**Lots 5 – 7 of Quarry Ridge Business Park, Windham, Maine**  
**Response to Comments**

We have reviewed the comments from your July 11<sup>th</sup> email regarding the proposed development of Lots 5-7 at Quarry Ridge Business Park and offer the below responses in the appropriate order.

**Planning (Amanda Lessard): July 11<sup>th</sup>, 2018**

**Civil Engineering (Jon Earle, PE): July 19<sup>th</sup>, 2018**

OVERALL GRADING PLAN OF: QUARRY RIDGE BUSINESS PARK ENTERPRISE DRIVE/BEDROCK TERRACE NORTH WINDHAM, MAINE FOR: COPART OF CONNECTICUT INC. 14185 DALLAS PARKWAY, SUITE 300 DALLAS, TEXAS 75254	PROJECT NO. 14135 SCALE 1"=50' SHEET 4 OF 9
---	---

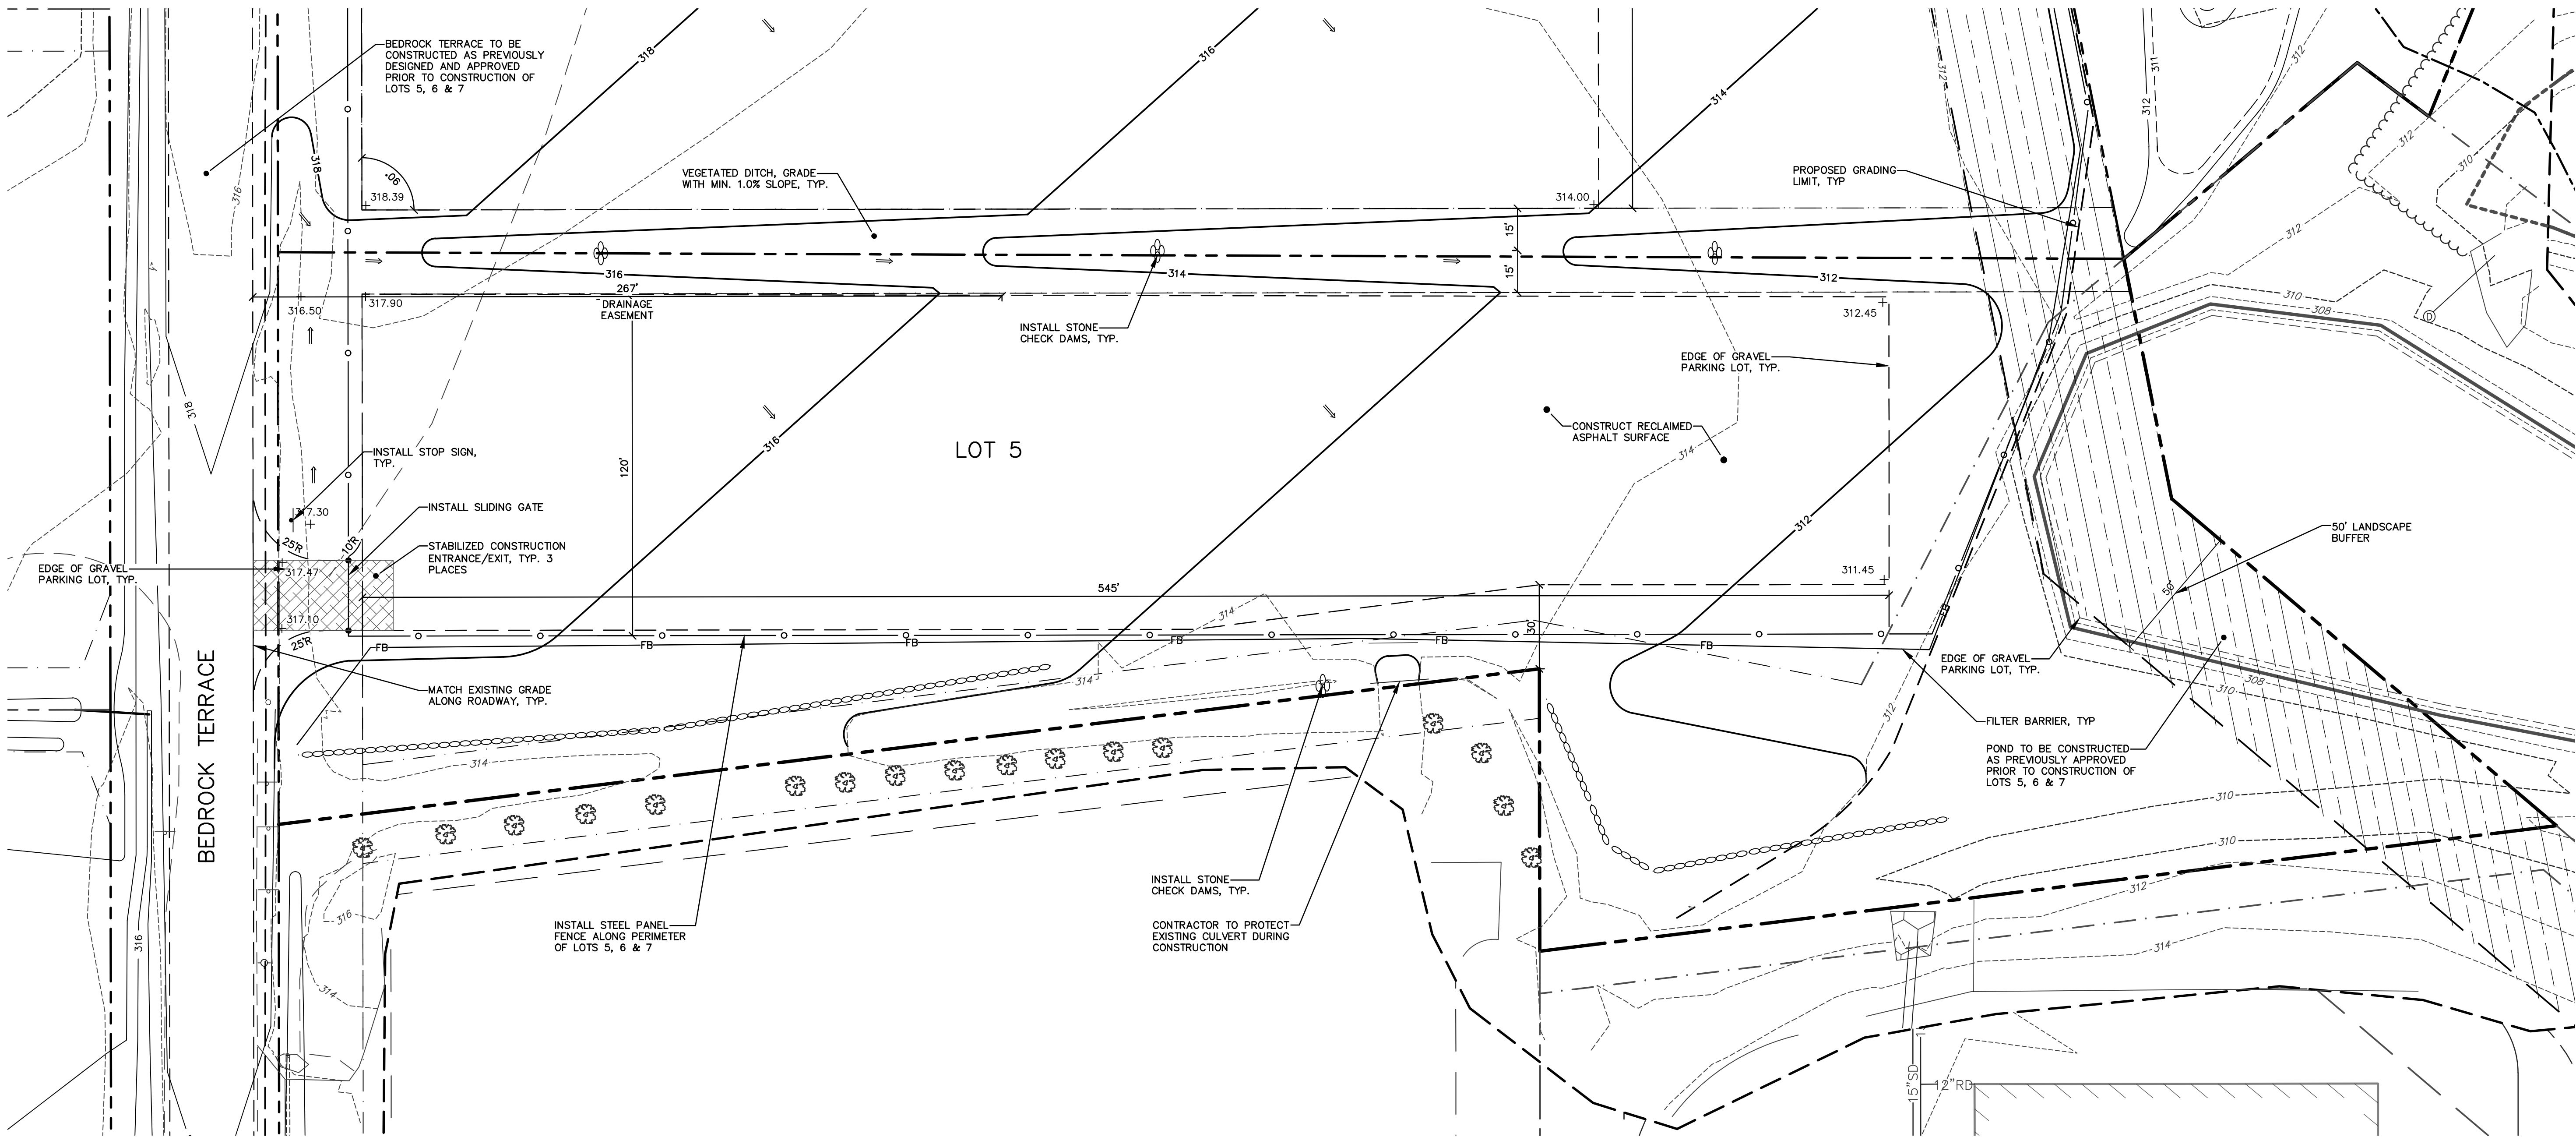
5. An Approval Block is not shown on the plan. This can be addressed post approval in plans that are printed for signature.

**Response: An Approval Block has been added to Sheet 4.**

7. The rear of Lots 5, 6, and 7 abut the Farm Zone, a residential district. Section 406.I requires a 50-foot-wide buffer strip, where no parking area shall be located. This should be more clearly indicated on the plan. 20 feet nearest the boundary shall be maintained as a landscaped buffer strip as defined, and the remaining 30 feet of the buffer strip shall also be used and maintained as a suitable planting area for lawn with trees, shrubs or other landscape material.

**Response: The 50-foot buffer at the back of Lots 5, 6, and 7 will be maintained. The 50-foot buffer overlaps the pond in the Lot 5 vicinity. As Phase I is a temporary arrangement, grass will be planted in the buffer areas. Phase II will combine Lots 5, 6, and 7, therefore any trees or shrubs planted during Phase I would be removed.**

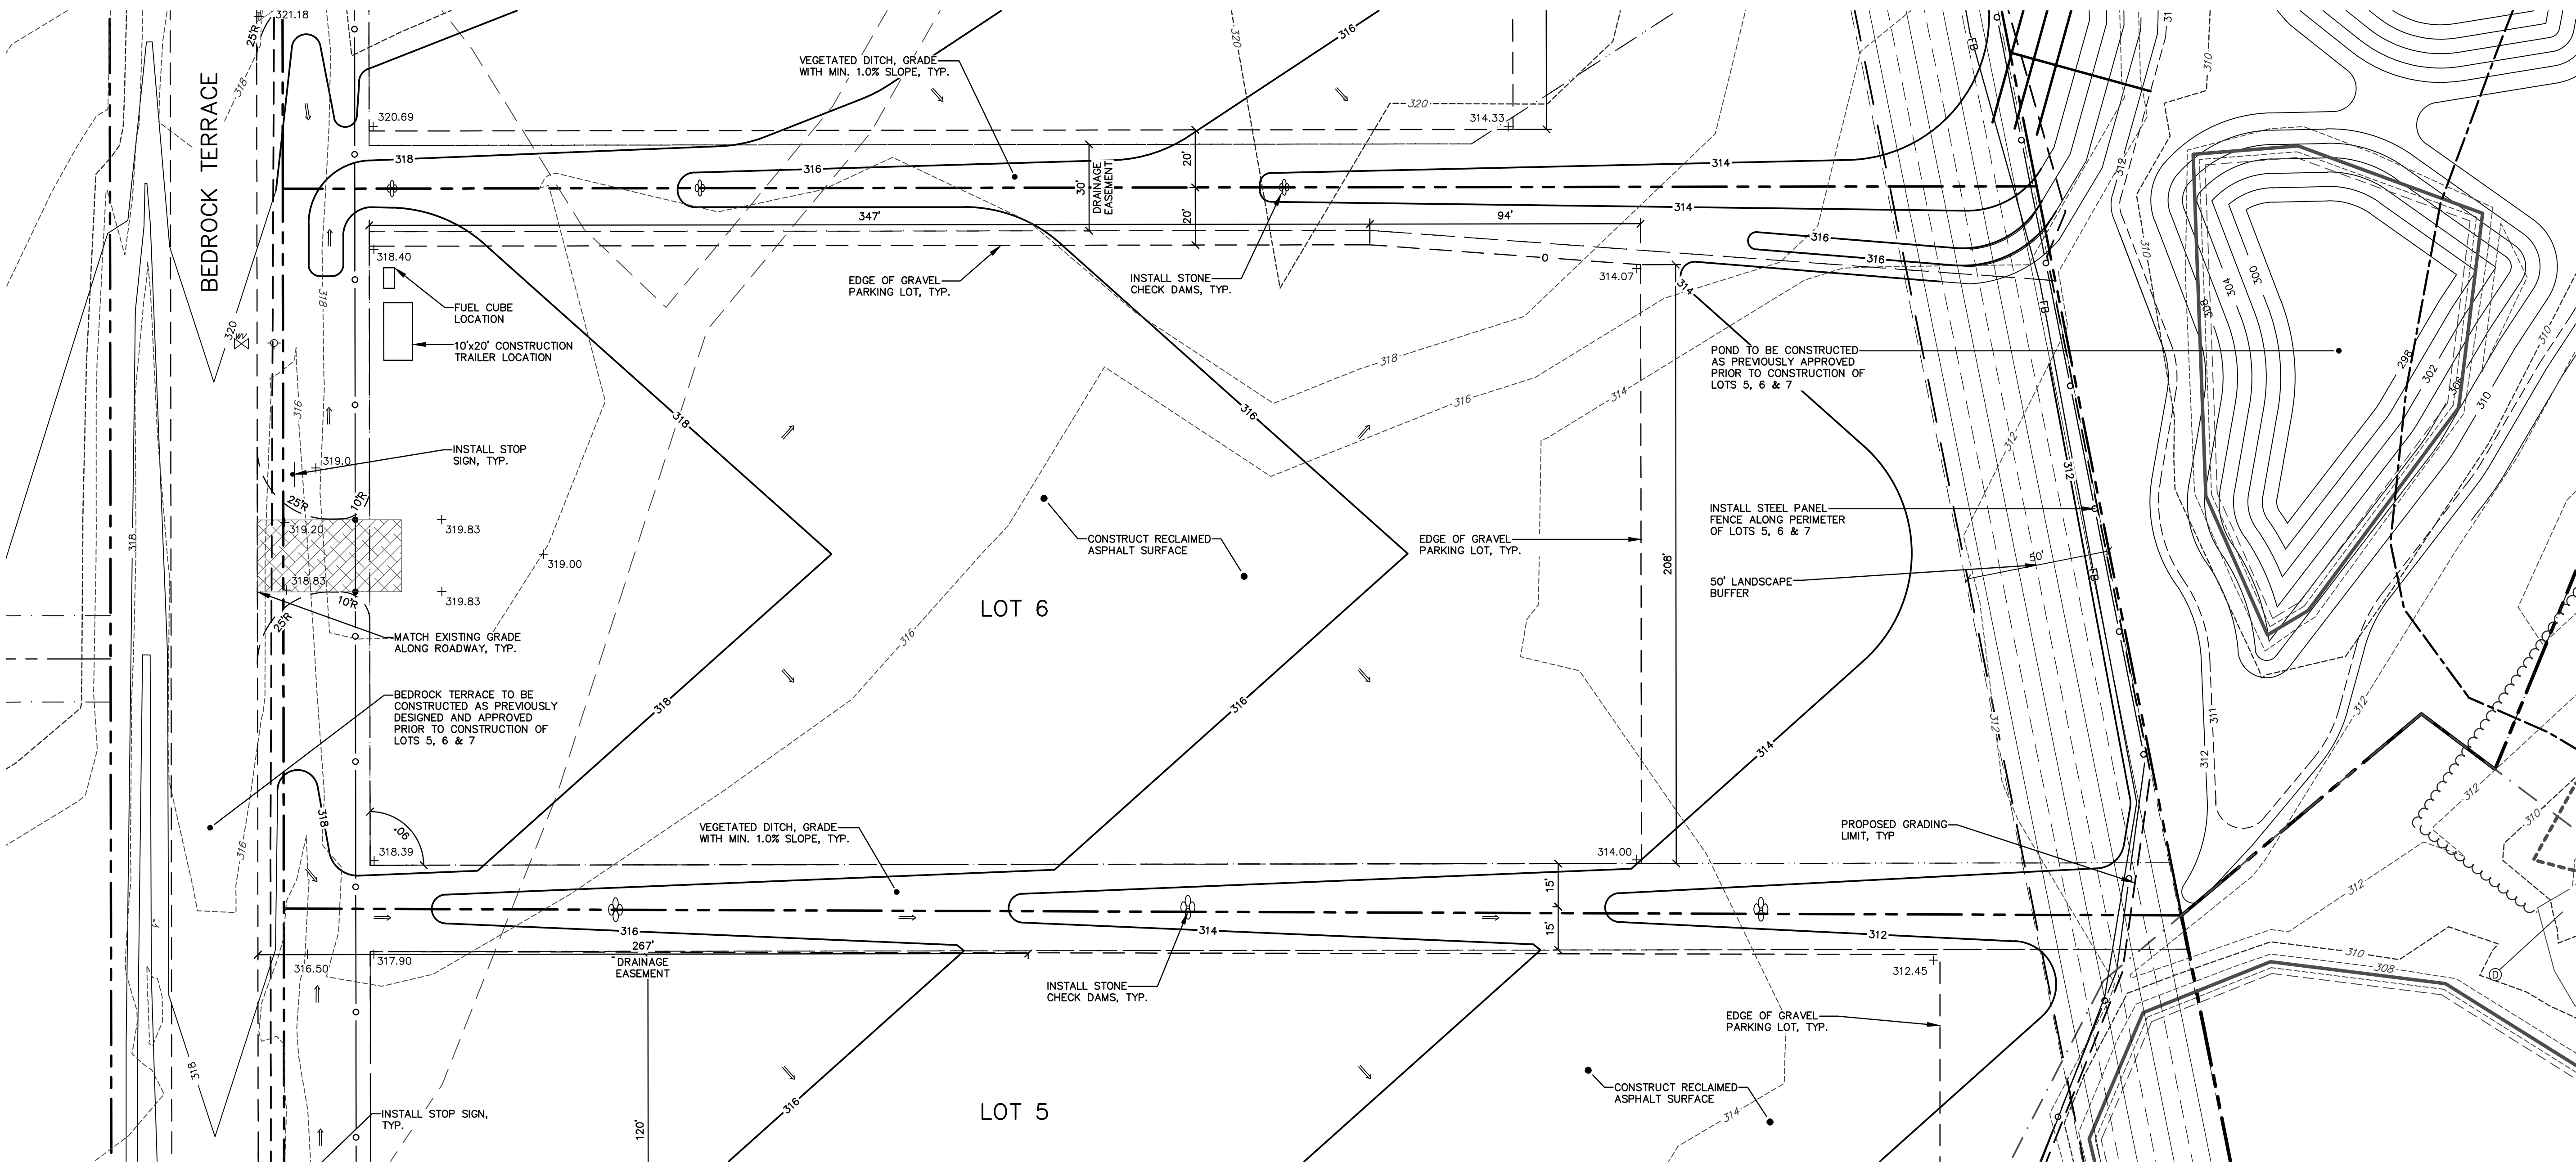
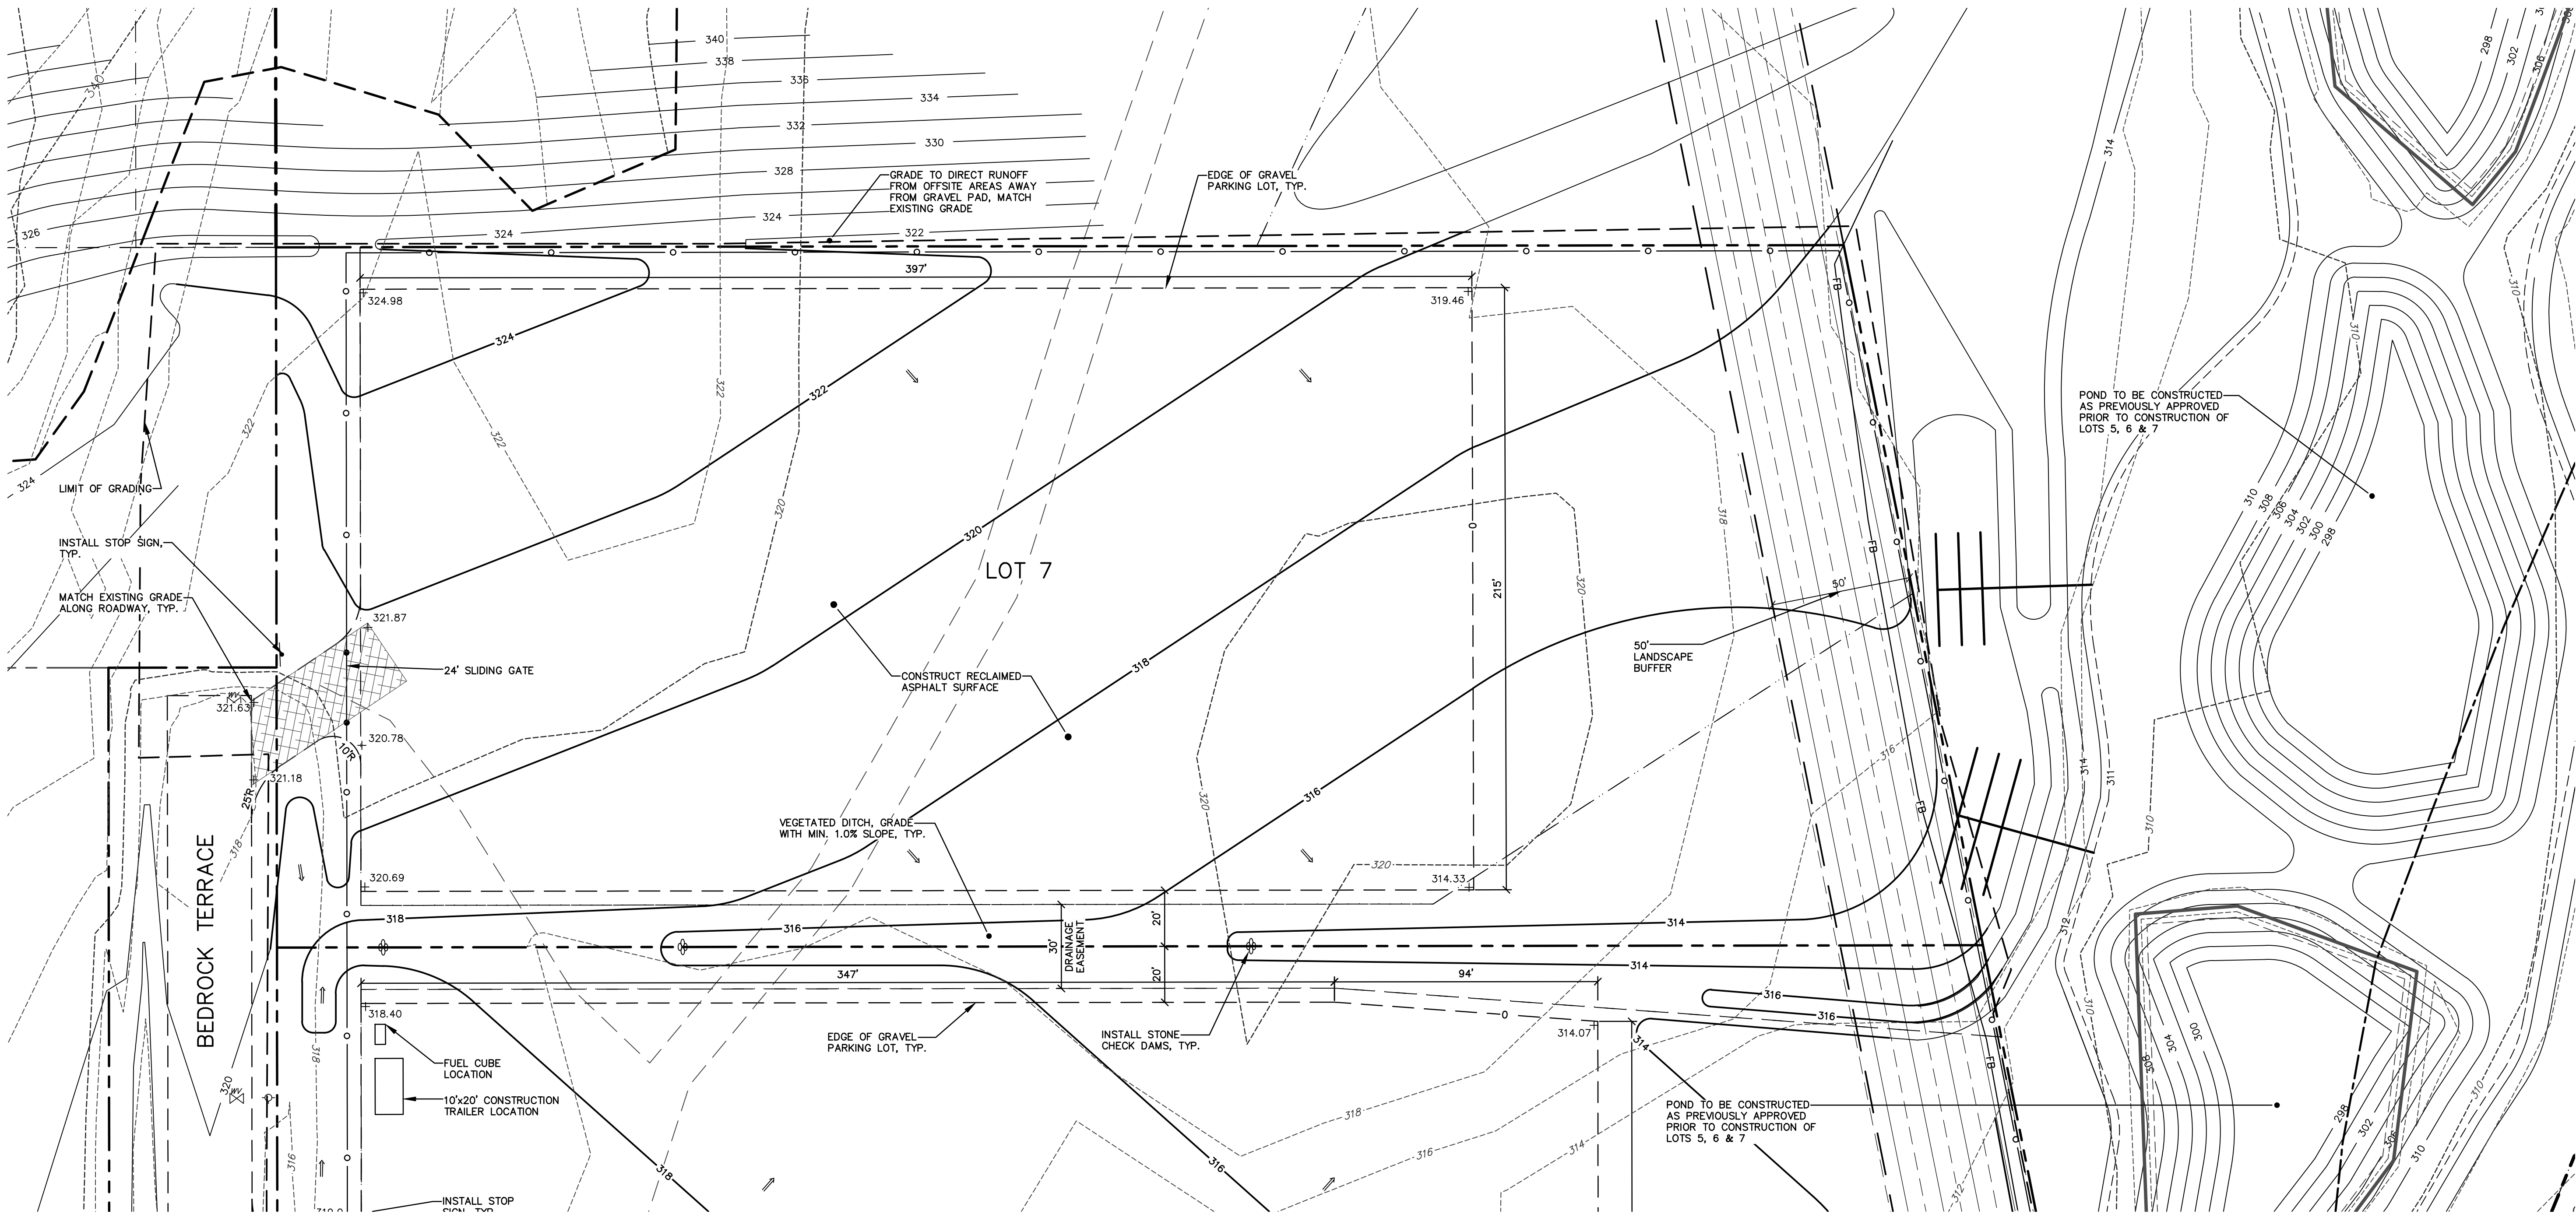
6. Section 406.I.6.f states that all parking lots shall maintain a 30 ft setback from all property lines. The parking lots on the submitted plans appear to be within that setback.

**Response: We respectfully request a waiver to Section 406.I.6.f. Currently, as show, the minimum separation from the property lines is 20 feet. Phase I is a temporary layout, and the additional 10 feet allows for more useable space to facilitate vehicle arrangement. Phase II will combine Lots 5, 6, and 7, thereby removing the internal buffer areas and setback requirements. The westerly edge of pavement on Lot 5 was changed to achieve a 30-foot setback. Additionally, Phase II will remove the external lot lines from Lot 7.**
